## Functional Agile Team Report 2018/05/28

### Issue Description: (e-mail 2018/05/15)

Fig 1 Fragment of PS865 layout with pertinent traces highlighted green

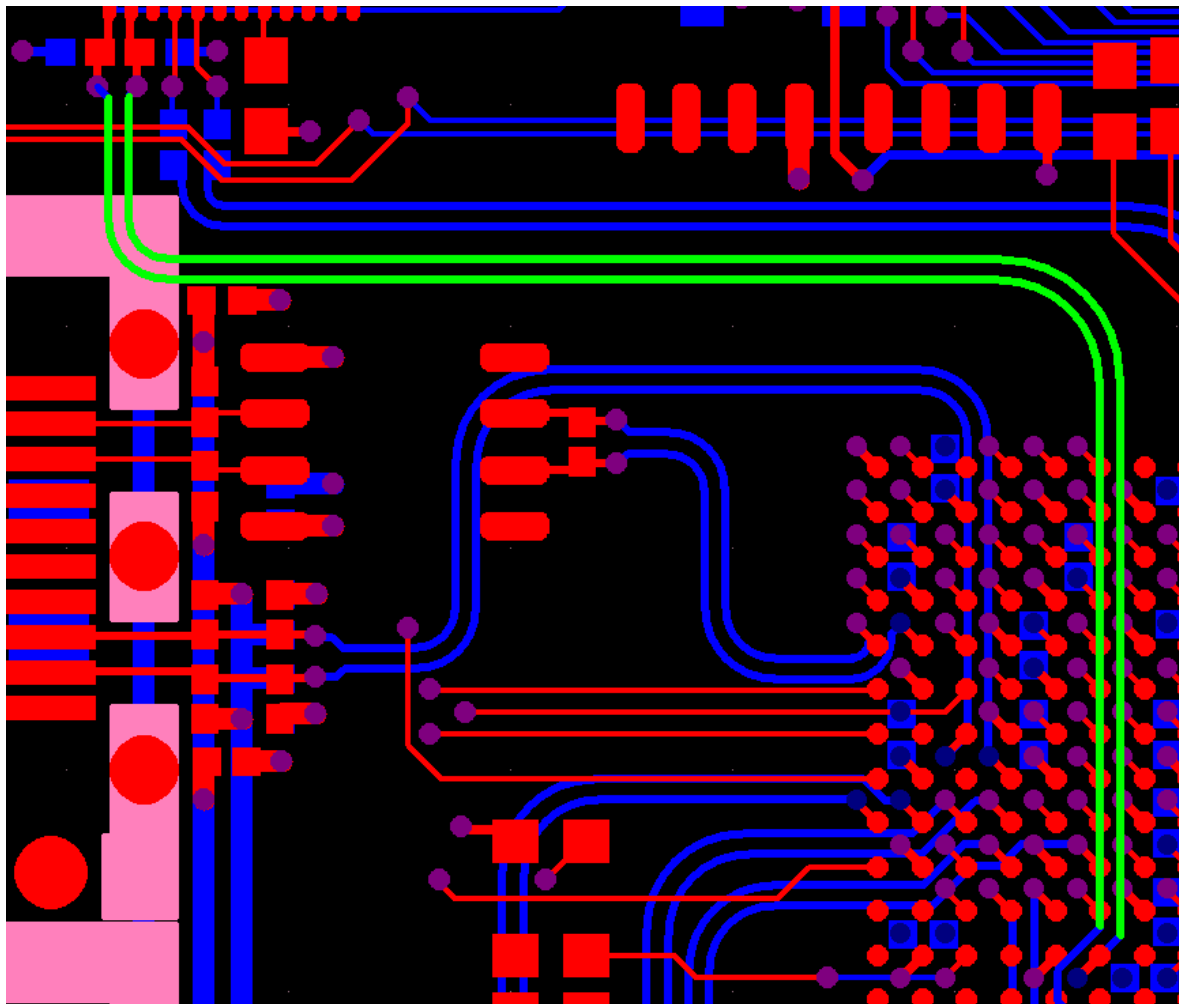
The layout pertinent to these two signals raises a question if such a low value resistors as termination are necessary.

Fig 2 Eye diagram of the voltage at pin 14 of D13

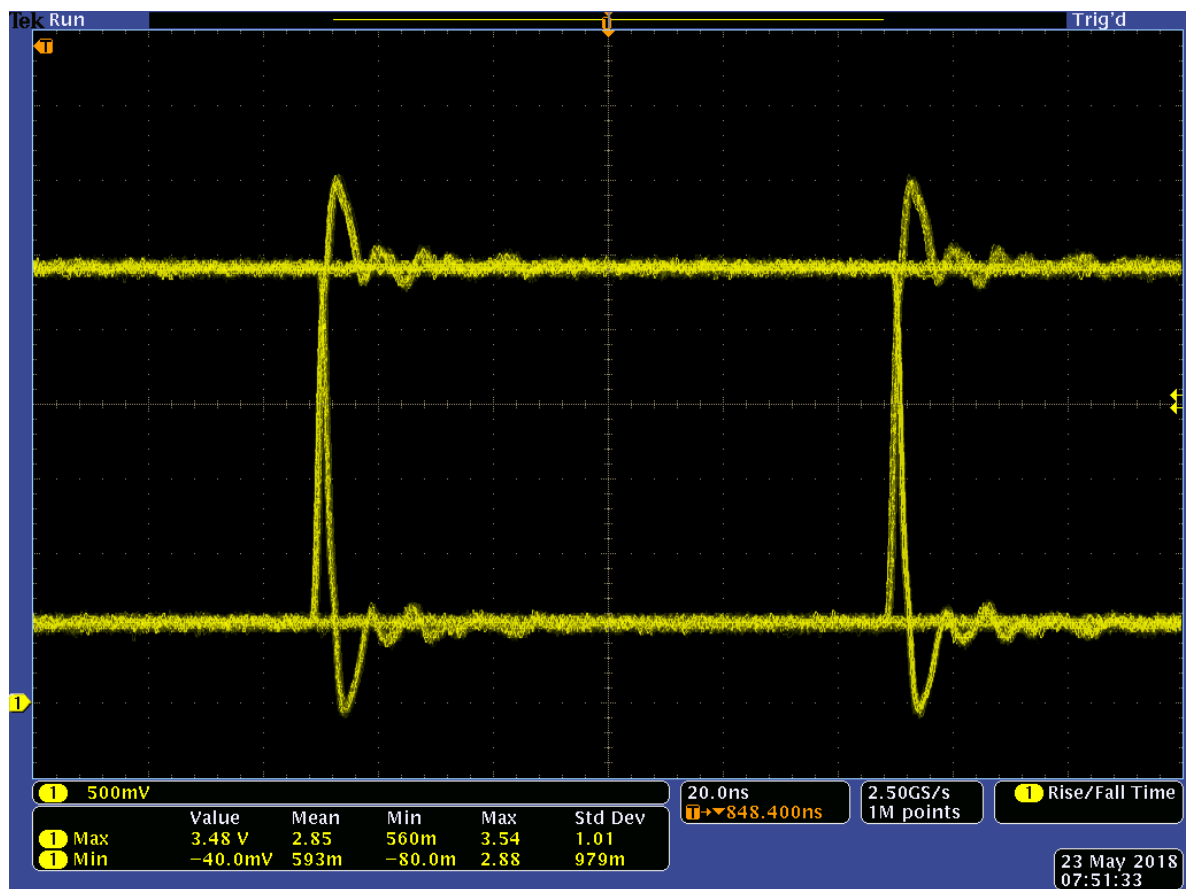
To check both RD+ and RD- waveforms the test was run with the FPGA output set to 24 mA. The results of these tests are shown in fig 2 and fig 3.

It could be seen that the currents related to the steady state here are even higher than seen in the sketch on page 1. This is assuming that the RD+ and RD- inputs present high impedance. In spite of some efforts trying to find out what are RD+ and RD- inputs the efforts proved to be in vain.

Fig 4 Eye diagram of the voltage at pin 14 of D13 with changed input network

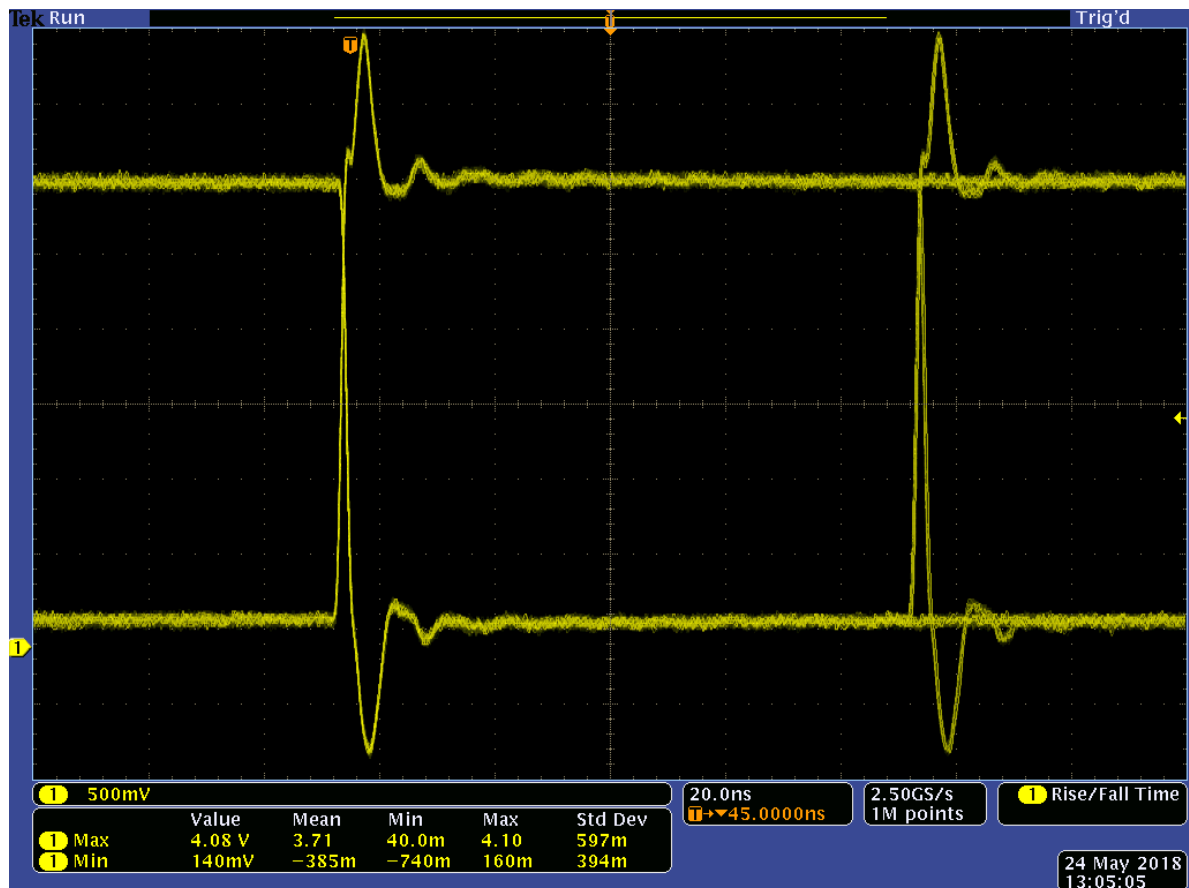
The simulation proved that the impact of the bias resistors (1K) on the waveform is negligible. The waveform becomes more symmetrical and the currents are within 24 mA.

The waveforms presented below are showing eye diagrams of both inputs with the corrected resistor network.

- The solution to the issue related to the FPGA currents is to change the biasing/termination network to one shown in the previous page.
- It is uncertain at this point if the switching transients are acceptable for the RD+ and RD- inputs, this still needs to be investigated
